# Access Compliance Report

## Public Rights-of-Way

Intersection ID: 18786	Main Street: NATIONS_FORD_RD	Cross Street: SLEEPY_HOLLOW_RD	Location: SW
ADA ID: 5863C3D9F6A2	Ramp Type: PerpDiag	Initial Pass/Fail: Fail	Overall Compliance: No
			Severity Score: 58.75

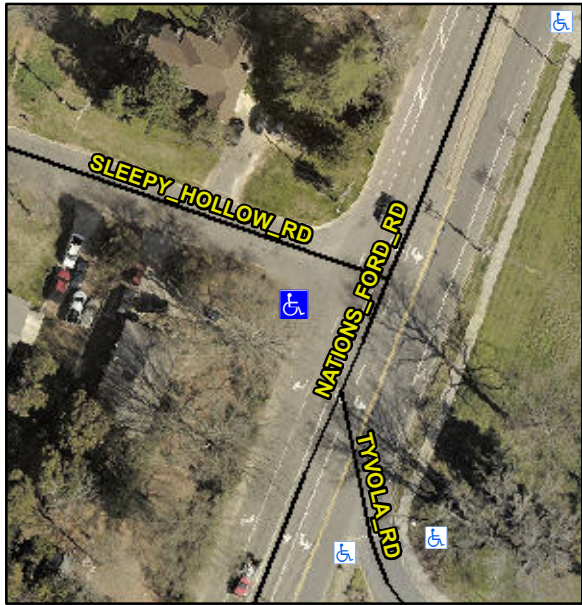
Codes/Mitigation Info/Possible Solution			Field Measurements/Component Compliance					
	Possible Solutions:		Compliance	Description	Data	Compliance	Description	Data
	Remove & Replace Curb Ramp With Two New Directional Ramps or Equivalent.		N/A	Ramp Length (in)	45.0	No	Ramp Slope (%)	12.6
			No	Ramp Width (in)	41.0	No	Ramp XSlope (%)	9.0
			N/A	Flare Type LT	N/A	N/A	Flare Type RT	N/A
			N/A	Flare Slope LT (%)	N/A	N/A	Flare Slope RT (%)	N/A
			N/A	Flare Traversable LT?	N/A	N/A	Flare Traversable RT?	N/A
			N/A	Landing Length (in)	N/A	N/A	DWS Provided?	N/A
			N/A	Landing Width (in)	N/A	N/A	DWS Contrast?	N/A
			N/A	Landing Slope (%)	N/A	N/A	DWS Length (in)	N/A
			N/A	Landing X Slope (%)	N/A	N/A	DWS Full Width?	N/A
Surveyor Notes:	N/A		N/A	Landing Curb? (Y/N)	N/A	N/A	DWS Offset (in)	N/A
			N/A	Shared Landing?	N/A			
	PROW/ADA:		N/A	Gutter Ponding?	N/A	N/A	Gutter Slope (%)	N/A
	Not Found, R304.5.1, R304.2.2, R304.5.3		N/A	Gutter Lip Ht (in)	N/A	N/A	Gutter X Slope (%)	N/A

N/A	Painted X Walk1?	No	N/A	Painted X Walk2?	No
				X Walk 1 Direction	To E		X Walk 2 Direction	To N
			N/A	X Walk 1 Width (in)	N/A	N/A	X Walk 2 Width (in)	N/A
				X Walk 1 Slope (%)	9.3		X Walk 2 Slope (%)	1.8
				X Walk 1 X Slope (%)	1.9		X Walk 2 X Slope (%)	7.0
			N/A	Ramp inside XWalk1?	N/A	N/A	Ramp inside XWalk2?	N/A
			Road Slope (%)	7.9	N/A	Clear Space?	N/A	
			Road X Slope (%)	4.5	N/A	Clear Space to XWalk (in)	N/A	
		N/A	Any Obstructions?	N/A	N/A	Storm Grate/Utility Hazard?	N/A	
			Obstruction Type			Storm Grate/Utility Type		
					N/A		N/A	
						Yes	Surface Condition? (G/P)	Good
